SR 141/Bethelview Road @ SR 9 (Atlanta Highway) Intersection Improvements

CSSTP-0007-00(999), P.I. No. 0007999
Forsyth County, Georgia

Value Engineering Study Report

September 2009

ALT. NO.
ROW-1
Sht. 2 of 5

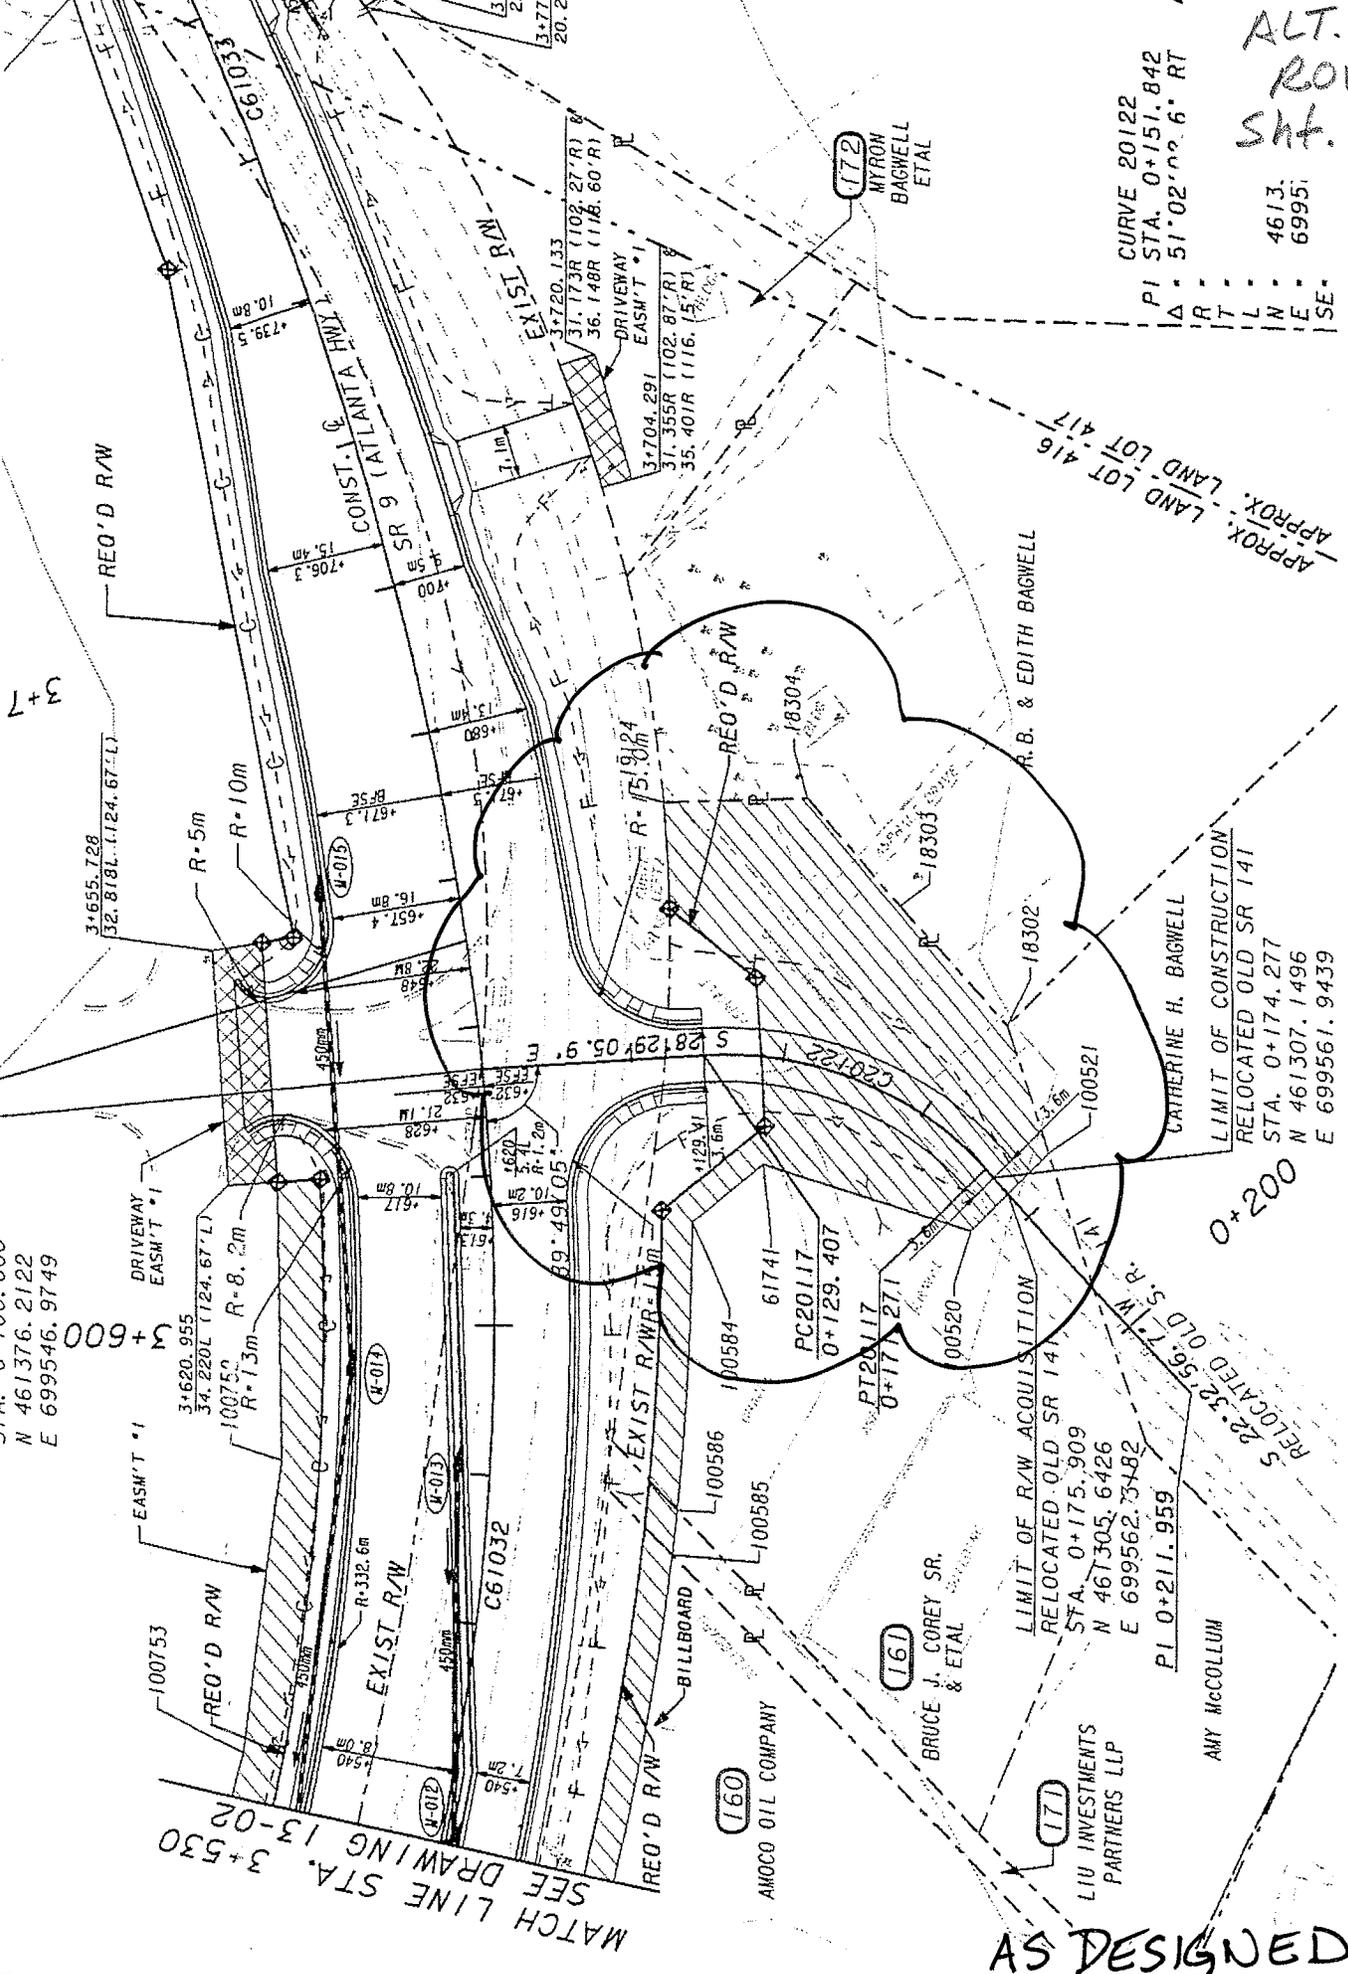
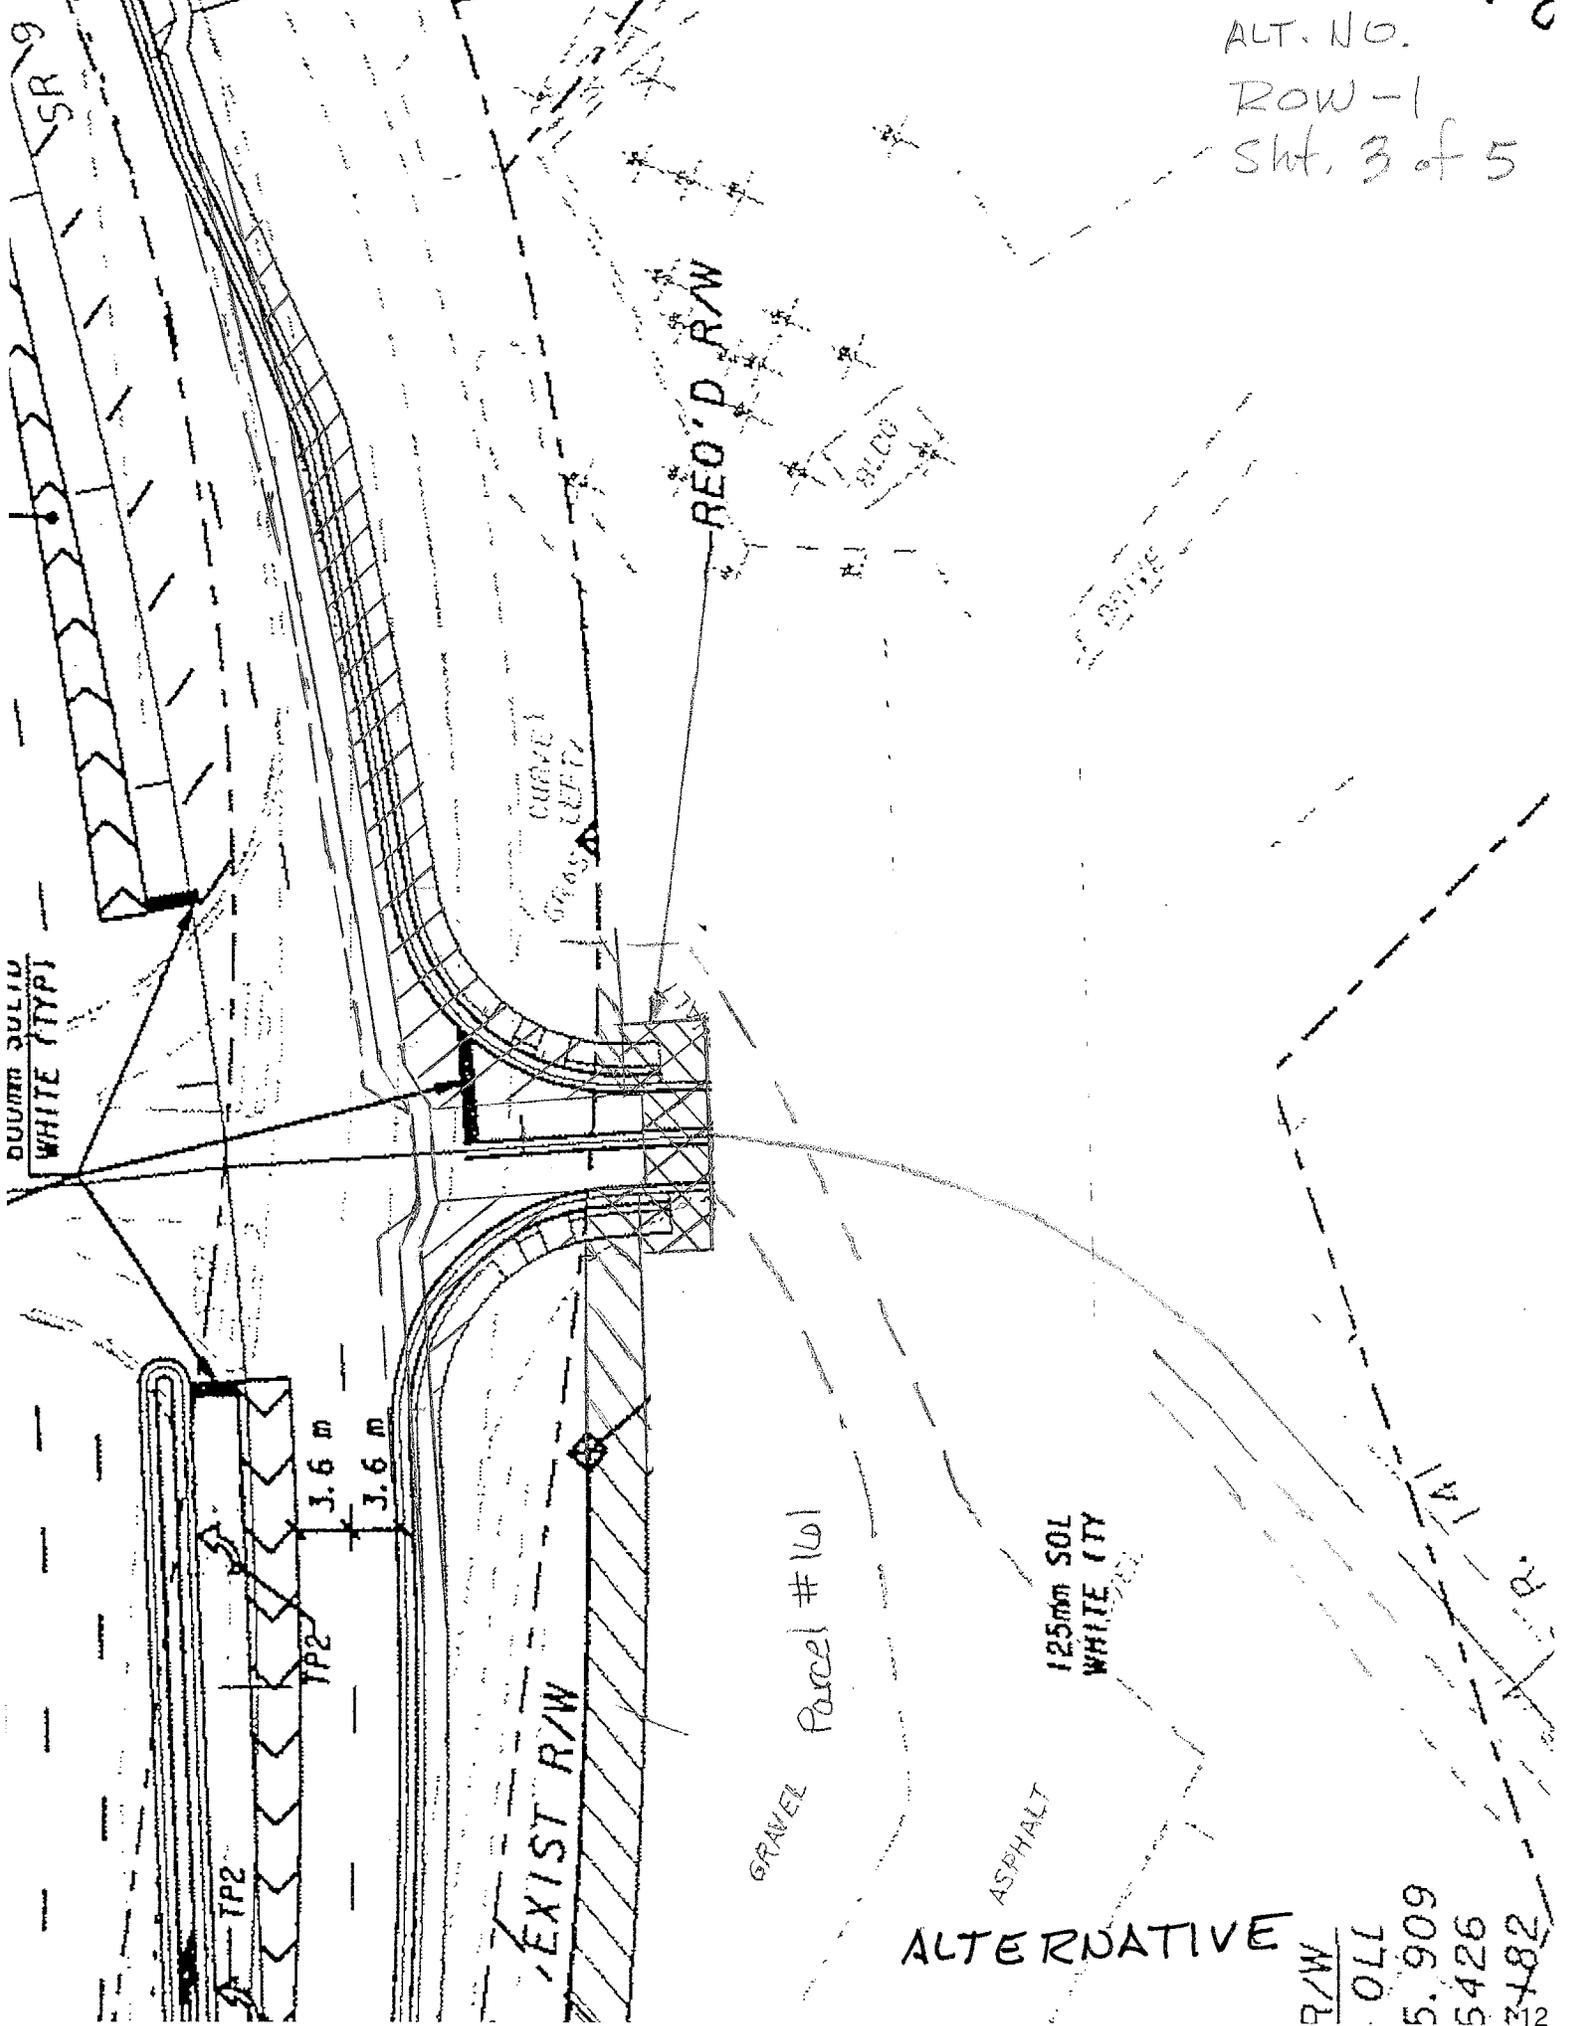
The original design ties into old SR 141 using full-depth roadway pavement with required right-of-way and easement at Sta. 3+635.

Use a driveway entrance to access Old SR 141.

Existing Old SR 141 is an old gravel and asphalt driveway entrance to four commercial/industrial properties. Using a commercial driveway entrance in lieu of full-depth pavement at Sta. 3+635 will reduce right-of-way and easement requirements.
